Proposed Minor Relaxation of Building Height Restriction for Permitted Flat Use
Tung Chung Town Lot 49, Tung Chung Road North, Lantau Island
(Section 16 Planning Application No. A/I-TCTC/71)

- Further Information No. 1 -

**Proposed Minor Relaxation of Building Height Restriction for Permitted Flat Use,
Tung Chung Town Lot 49, Tung Chung Road North, Lantau Island
(Section 16 Planning Application No. A/I-TCTC/71)**

– Further Information No. 1 –

Figure 3.2: Building Separation and Building Setback

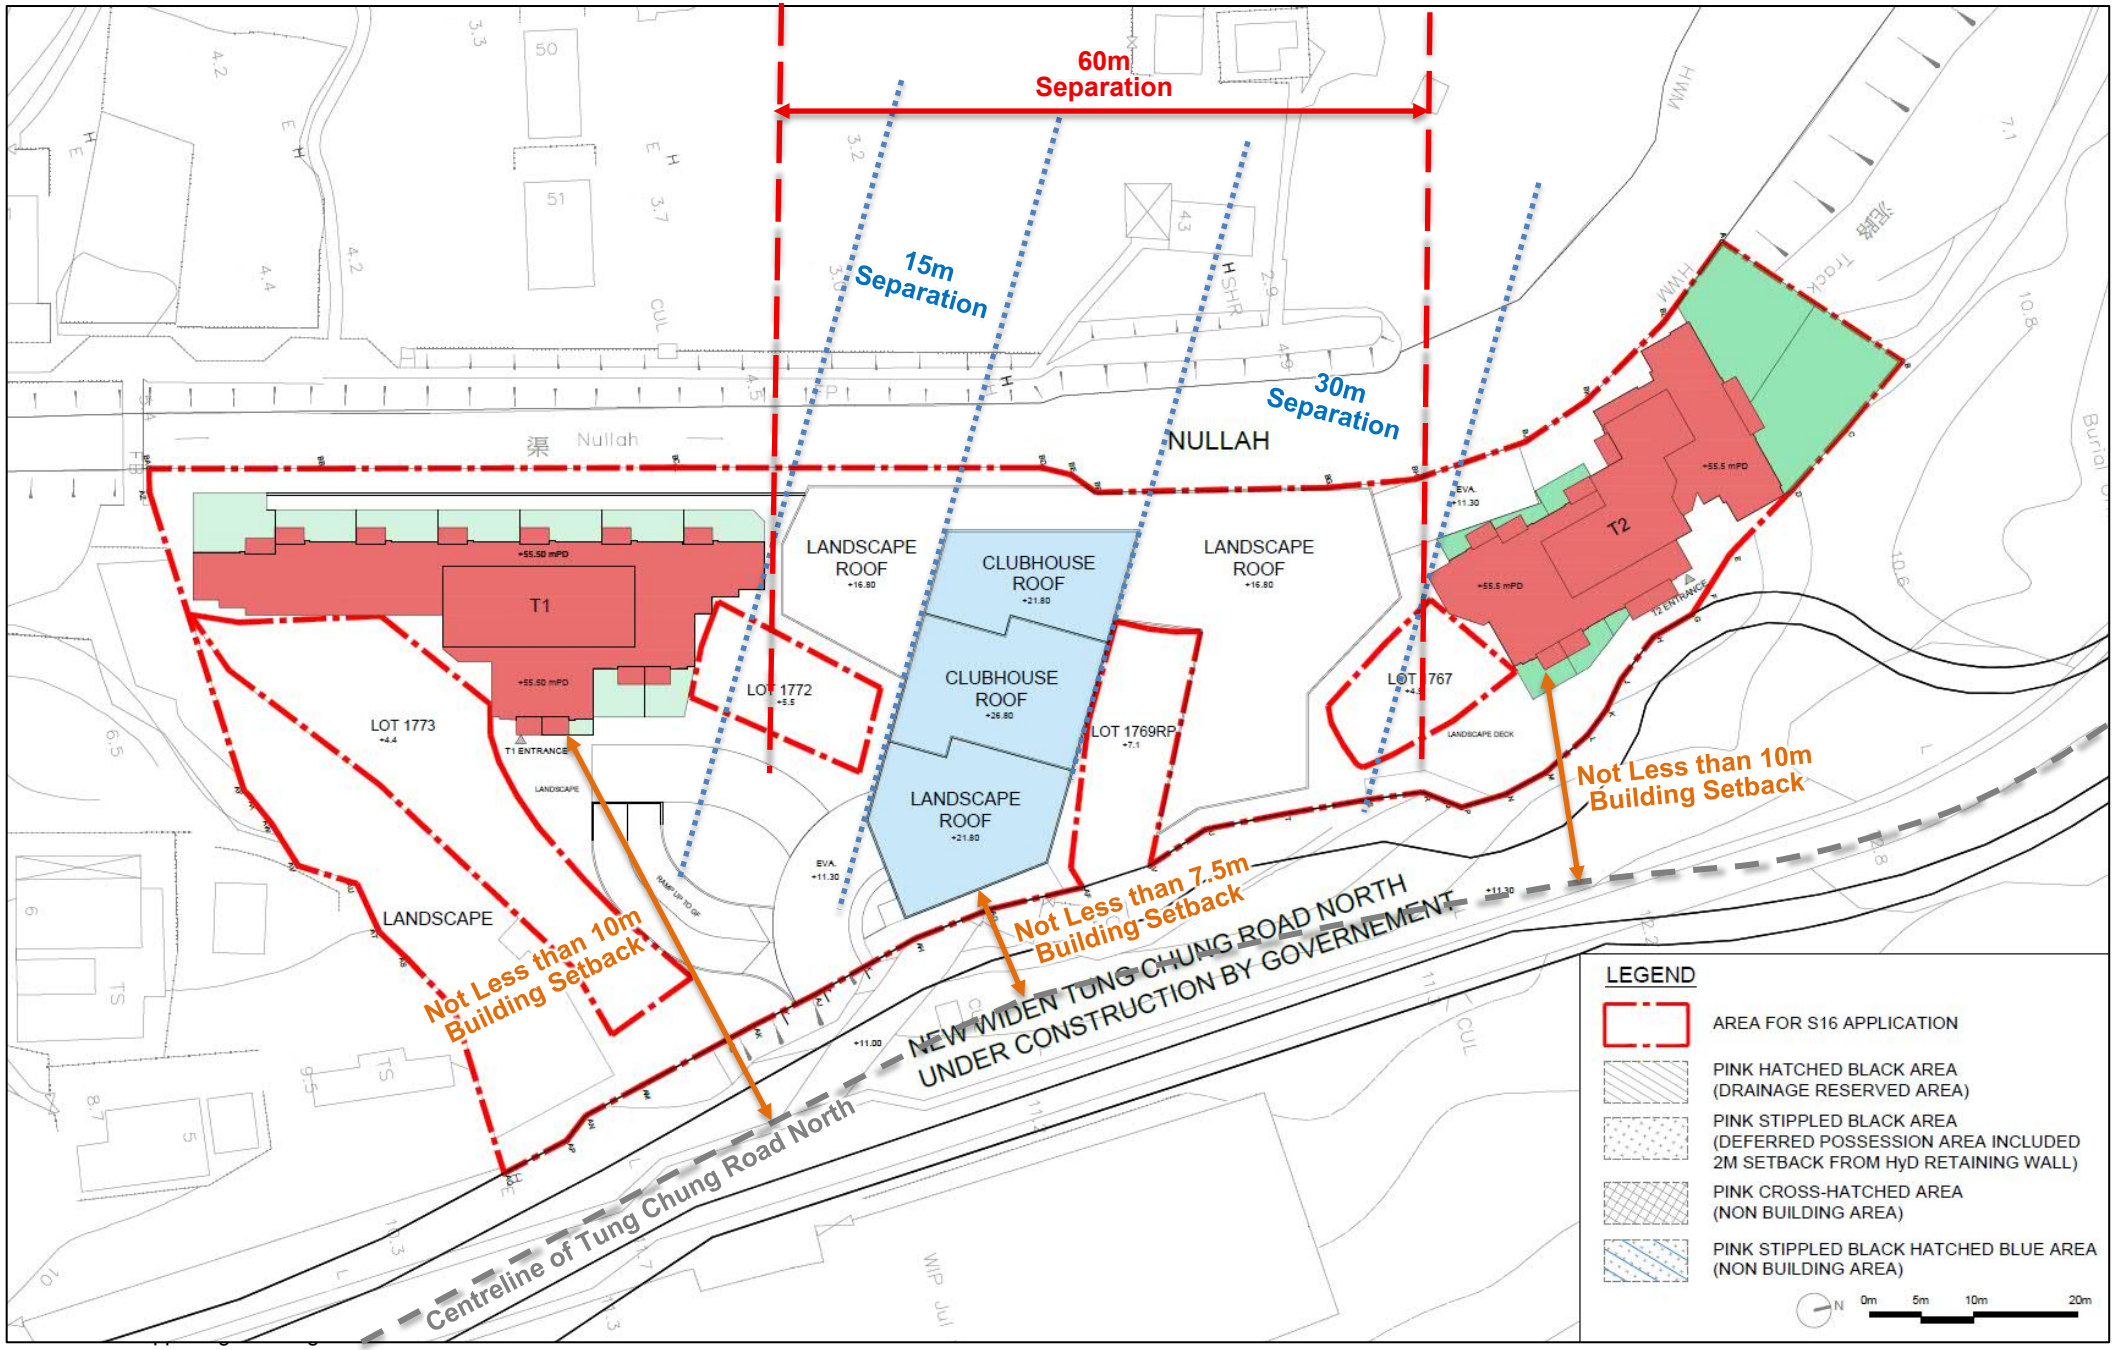
4.2	Para. 3.3.2 – It is suggested to indicate clearly the width of the proposed setback on the layout plan of the proposed scheme.	The proposed width of the setback has been indicated on Figure 3.2 of the Supporting Planning Statement (**Annex A** refers).

Figure: 1.1	RAMBOLL
Title: Site Location Plan	Drawn by: SC Checked by: TW
Project: Proposed Minor Relaxation of Building Height Restriction for Permitted Flat Use at Tung Chung Town Lot 49, Tung Chung Road North, Lantau Island	Rev.: 1.0 Date: Feb 2026

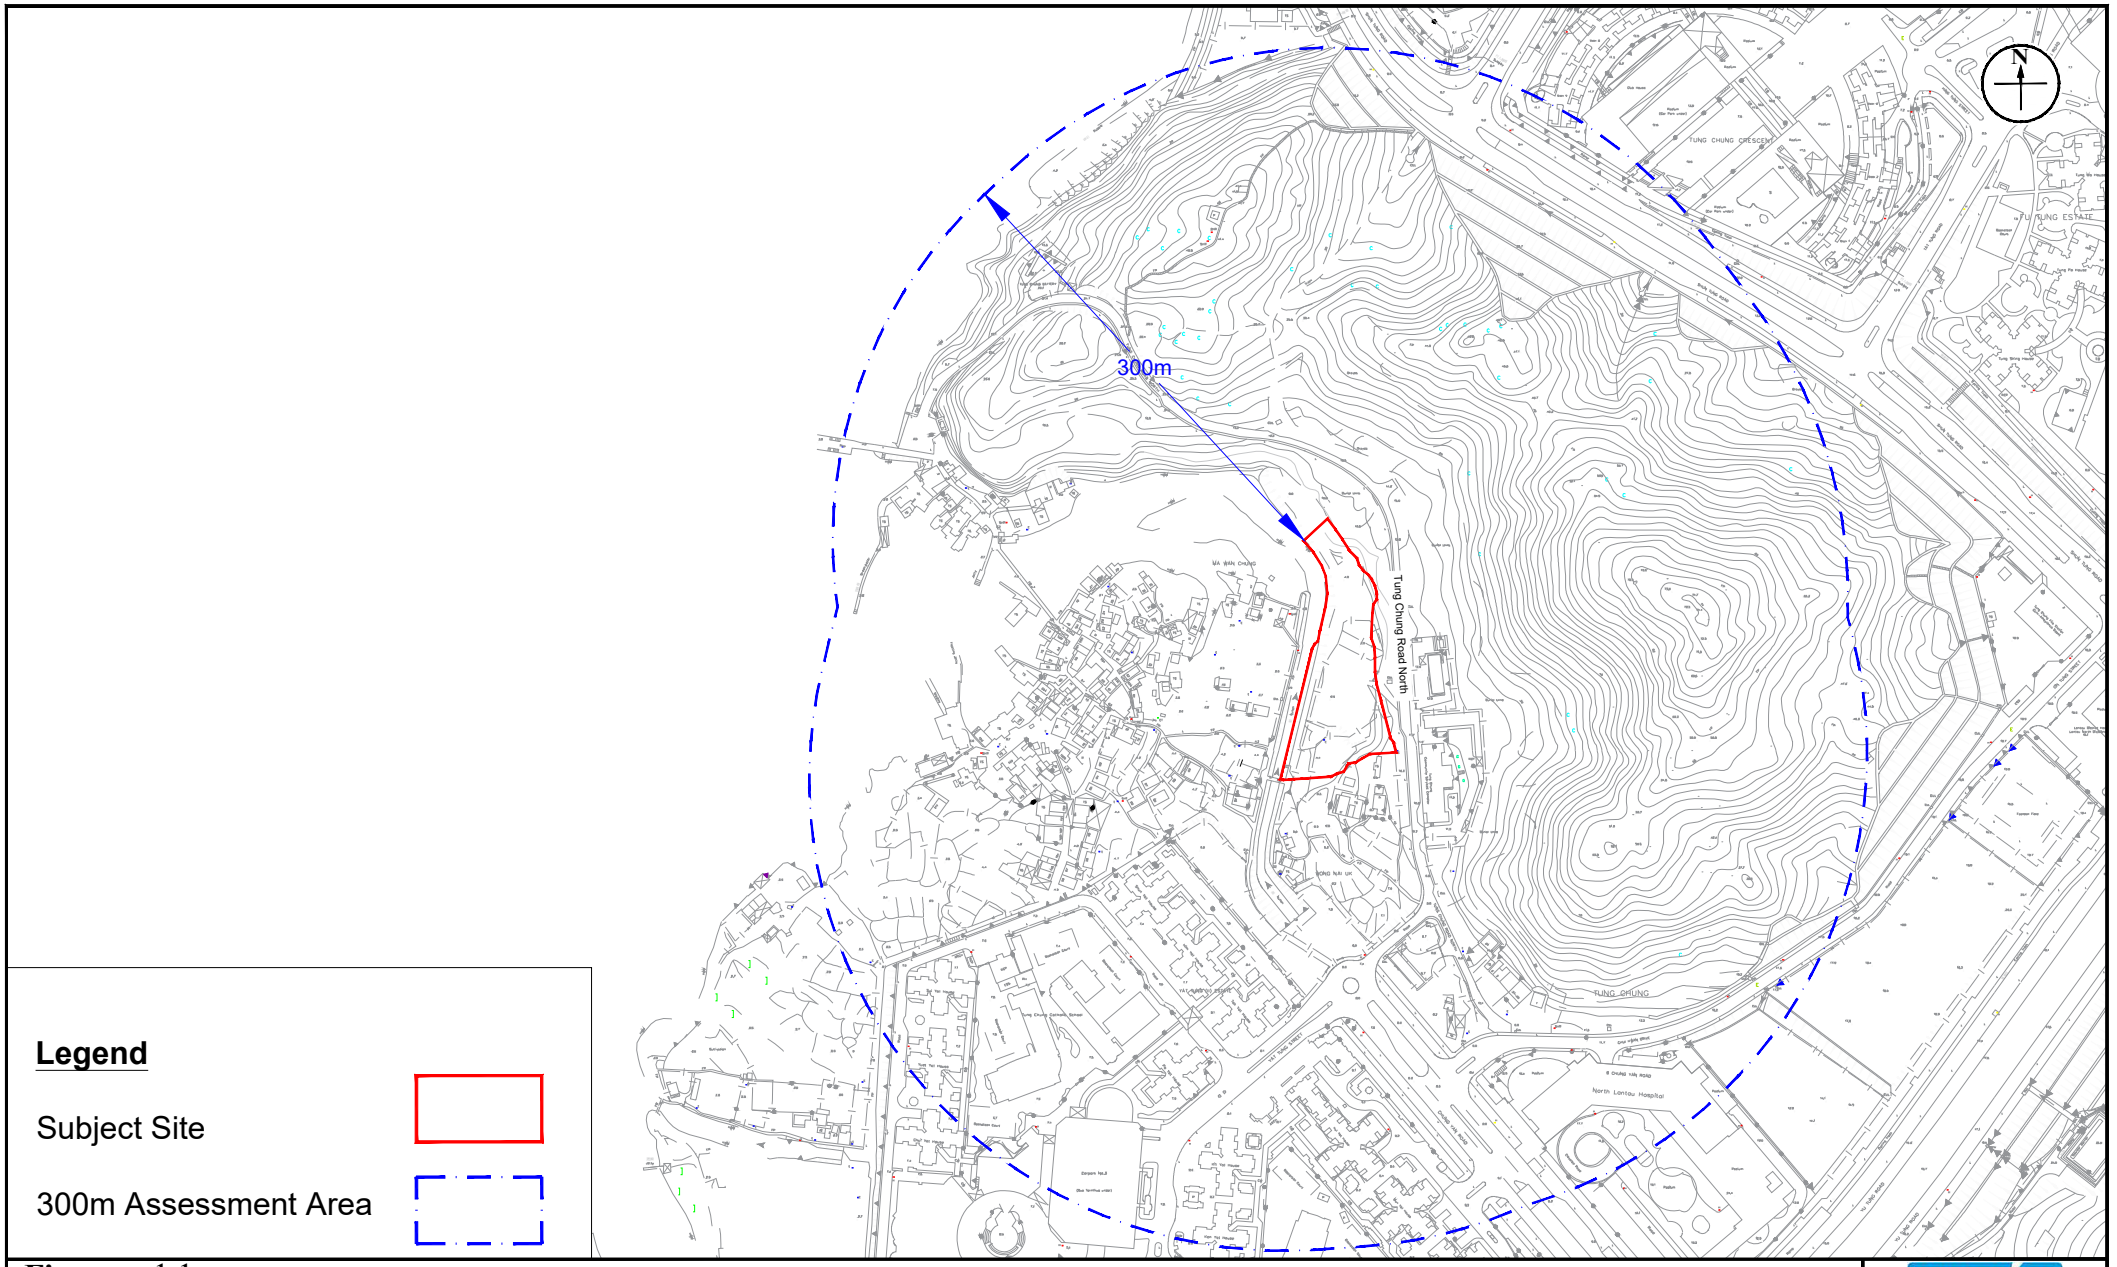
Item	Comments	Our Responses
3.34	Figure 1.1a, a distance of 119m is indicated on the site location plan, please include such mark-up in the legend.	Figure 1.1a of the EA has been renumbered to Figure 1.1 which only show the Subject Site and its 300m Assessment Area. Distance of 119m has been removed.
	Waste Management

Figure: 4.1b

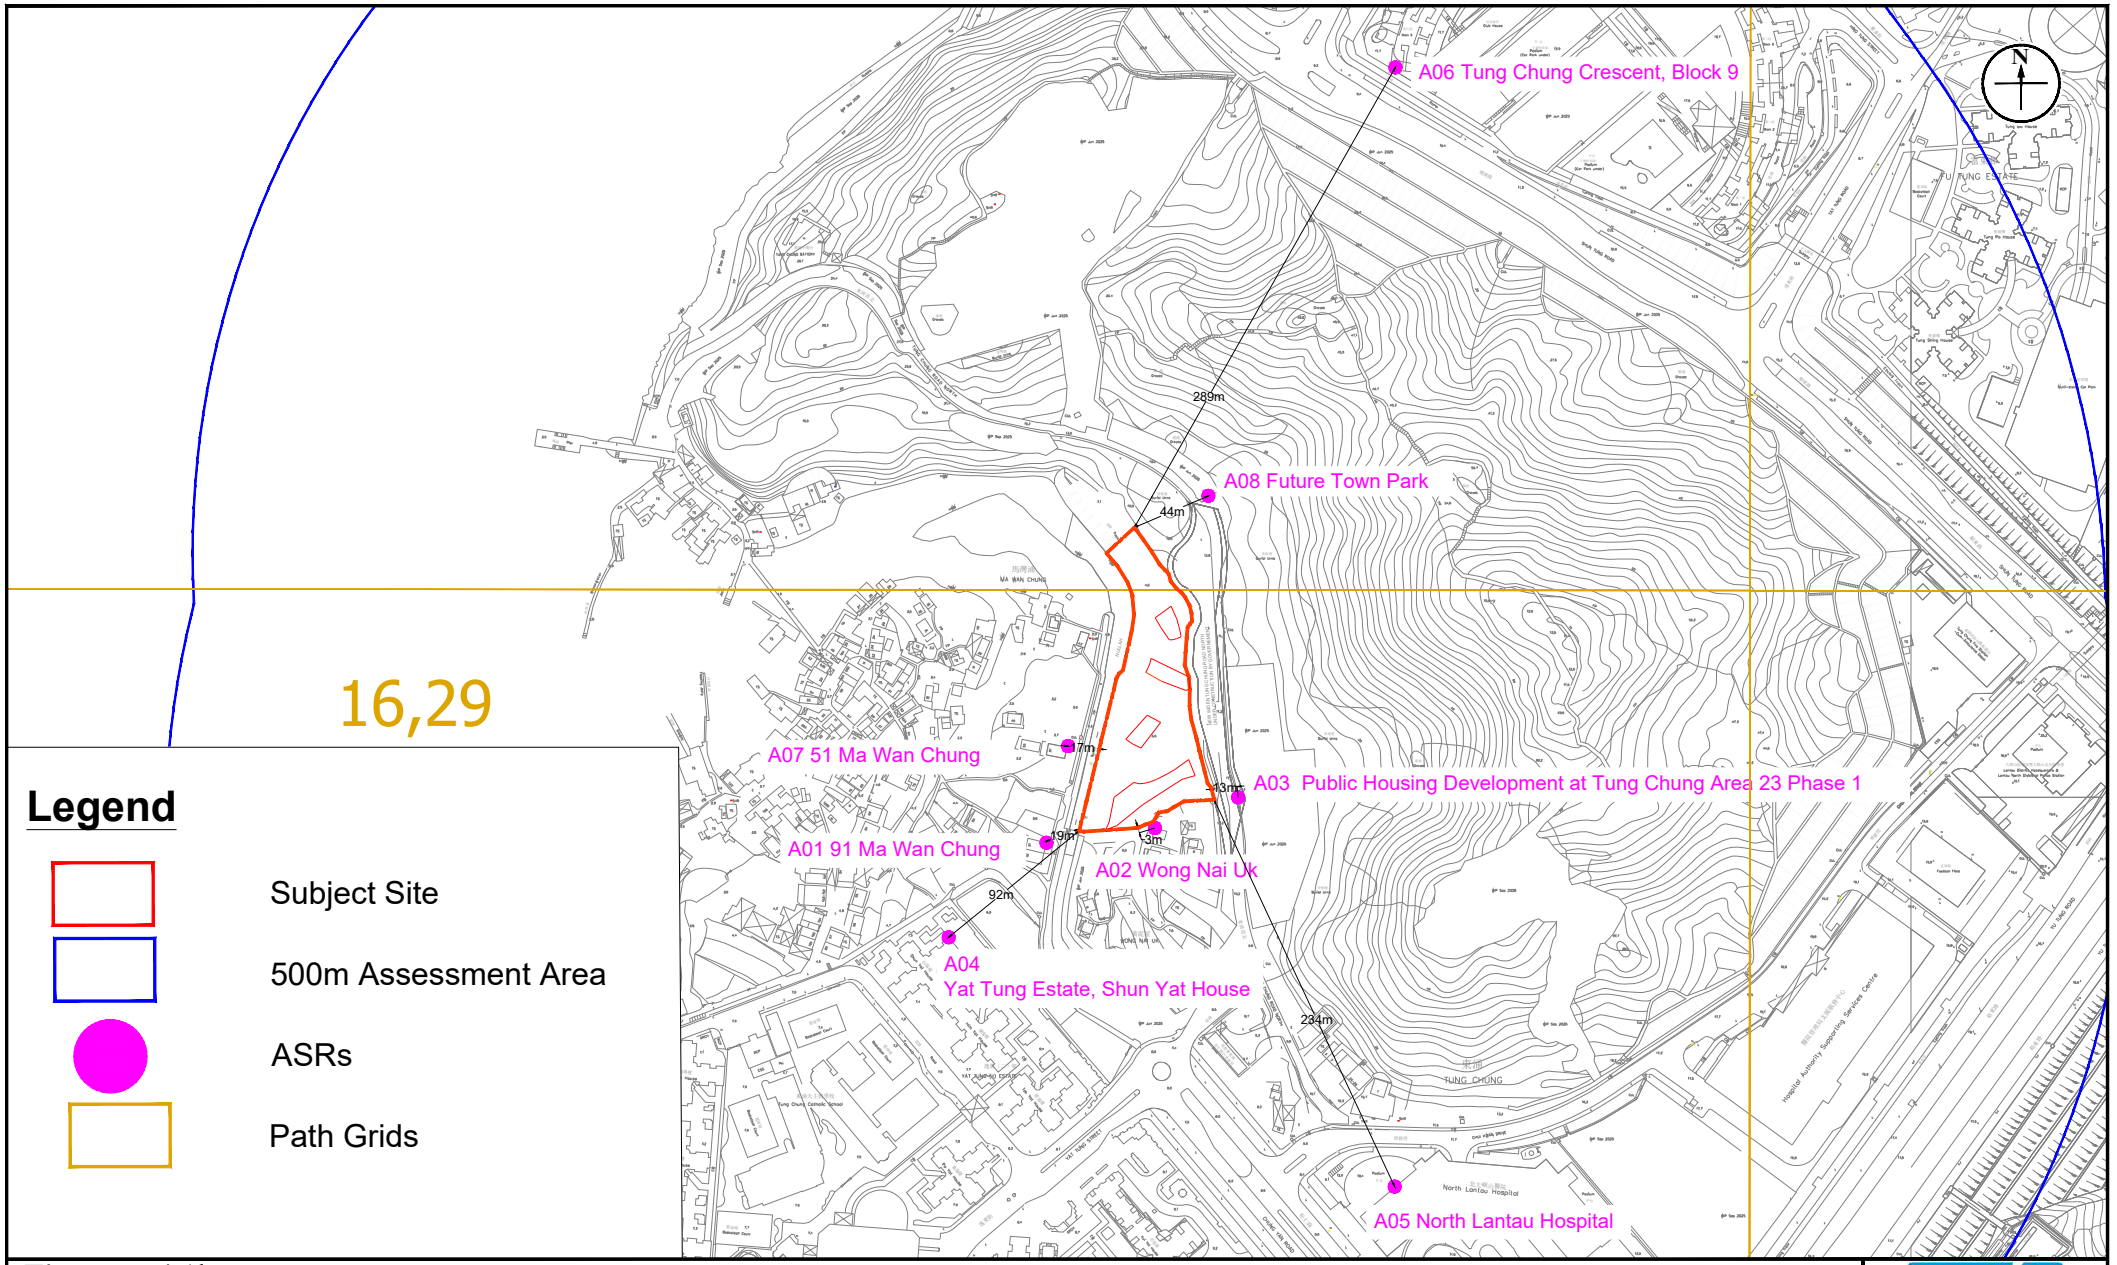
3.11	Figure 4.1b – Please use larger font size for separation distance with A03.	The font size has been enlarged for A03 in Figure 4.1b of the EA.
3.12	Figure 4.2 – (a) Please show the complete 500m assessment area. (b) Please remove the ASRs and the separation distance that are not mentioned in Table 4.8, and use larger font size for separation distance (12m) with concurrent project P2.	(a) The 500m assessment area has been shown in Figure 4.2 of the EA. (b) Figure 4.1 of the EA has been updated accordingly and in line with Table 4.7.

Figure: 4.5	RAMBOLL
Title: Marine Route of Local Vessels & Location of Mooring Sites	Drawn by: SC Checked by: TW
Project: Proposed Minor Relaxation of Building Height Restriction for Permitted Flat Use at Tung Chung Town Lot 49, Tung Chung Road North, Lantau Island	Rev.: 1.0 Date: Jan 2026

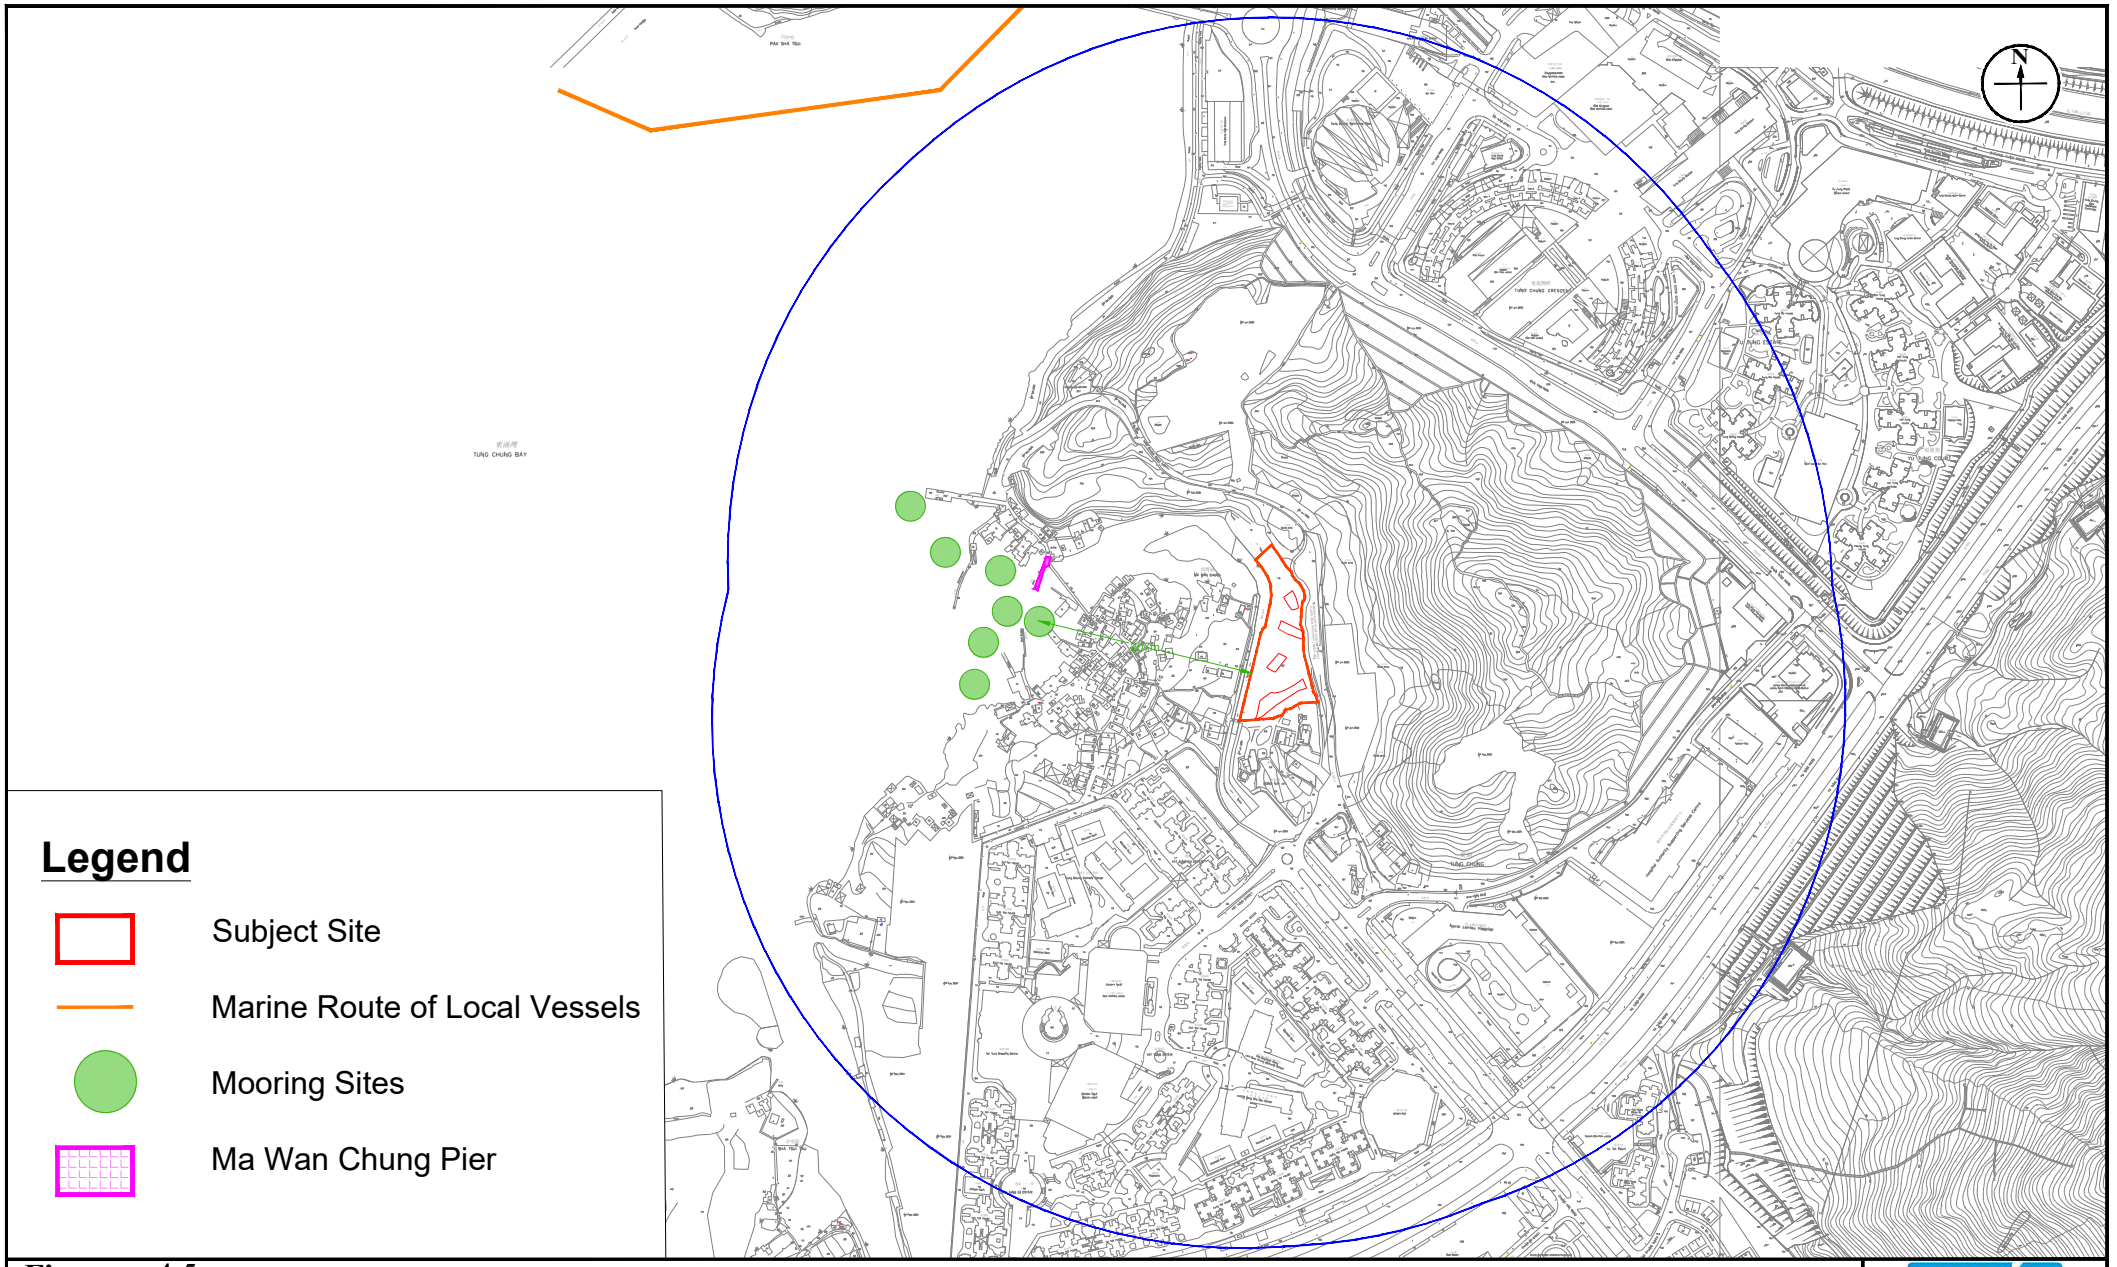
3.8	Section 4.6.2 – According to Figure 4.5, there are some jetties and piers near Ma Wan Chung (e.g. Ma Wan Chung Pier) that fall within the assessment area. Please review if there are any marine emissions that will affect the air quality of the proposed development.	Marine emission from Ma Wan Chung Pier has been discussed in Section 4.6.2 of the EA.
